1st Further Information

**Temporary Open Storage and Warehouse (Construction Materials and Machinery)
and Associated Filling of Land for a Period of 3 Years in "Agriculture" Zone,
Various Lots in D.D.103 and Adjoining Government Land, Kam Tin, Yuen Long, New Territories**

(S.16 Planning Application No. A/YL-KTS/1121)

Responses-to-Comments

DWG NO.
ANNEX I

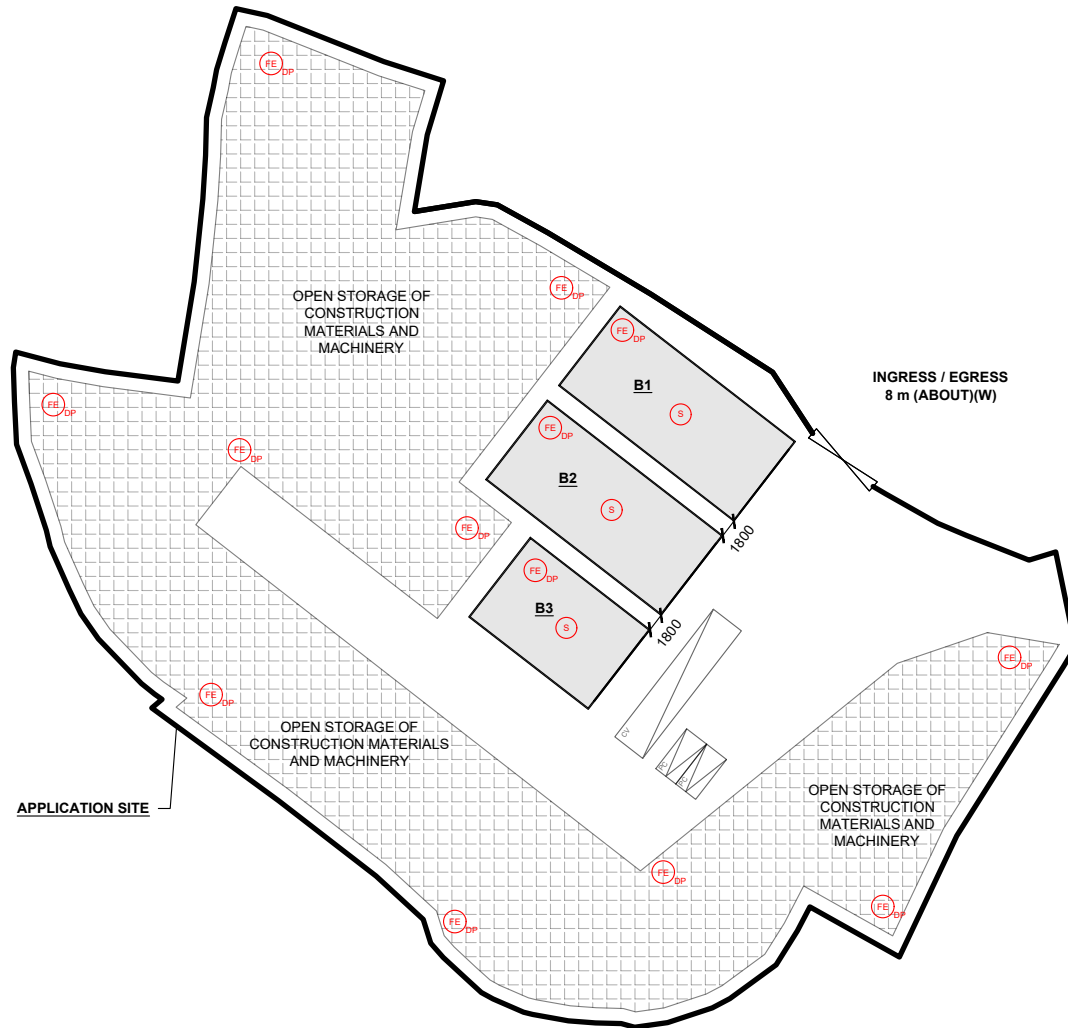
2. Comments of the Director of Fire Services (D of FS) (Contact Person: Mr. YUEN Tsz-fung; Tel: 2733 7781)		
(a)	Based on the submitted FSI proposal, our comments are as follows: Sufficient number of stand-alone fire detectors shall be provided at Structure B1, B2 & B3; and	Noted and revised accordingly. Please refer to the revised fire service installations proposal for your consideration (Annex I).

(b)	For open storage area which does not involve the erection of enclosed structures, the number of fire extinguisher required to be provided = [Storage Area (m2)] x [0.003].
